安费诺(常州)电子有限公司
Amphenol (Changzhou) Electronics Co.Ltd.

Customer Notification of Change 客户变更通知
(ECN NO:ECNG22101002)

产品系列 Product Serial: PwrLok 10mm-90 2POS&3POS Plug Conn

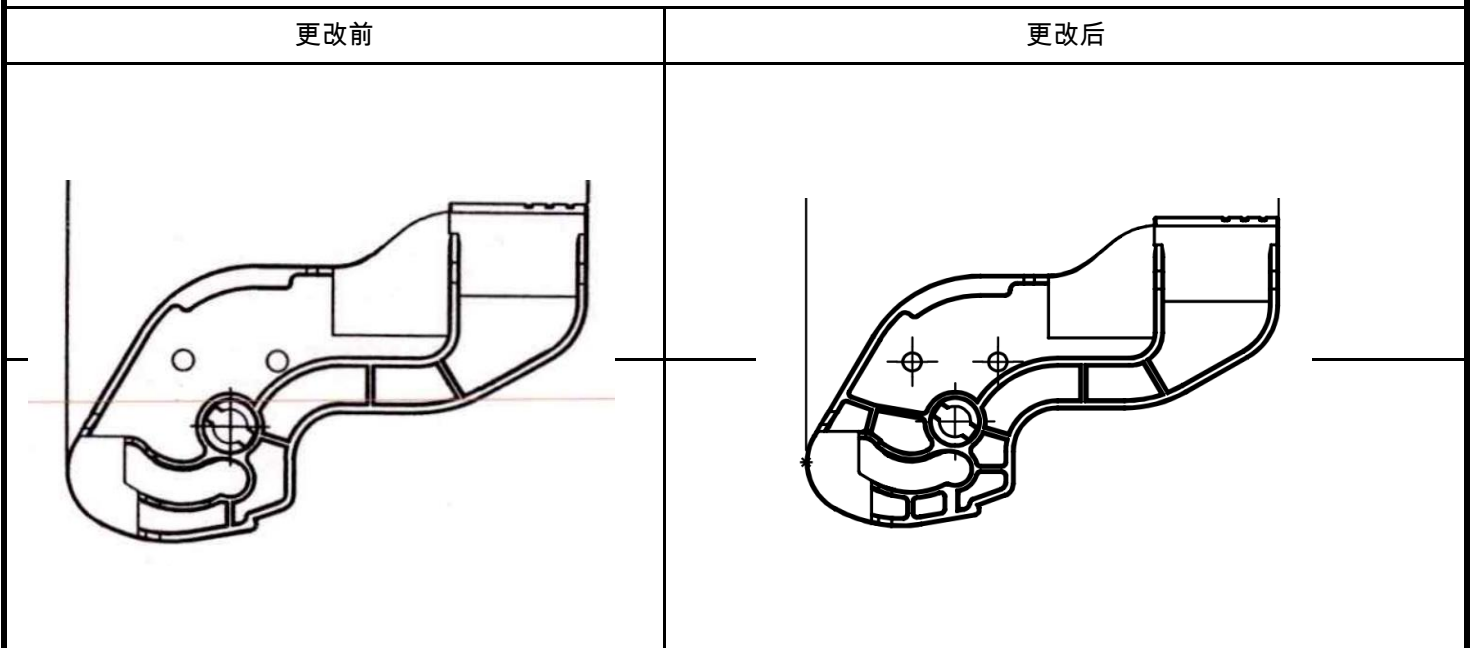
改善摇杆结构，增加强度(Improve rocker structure and increase strength)
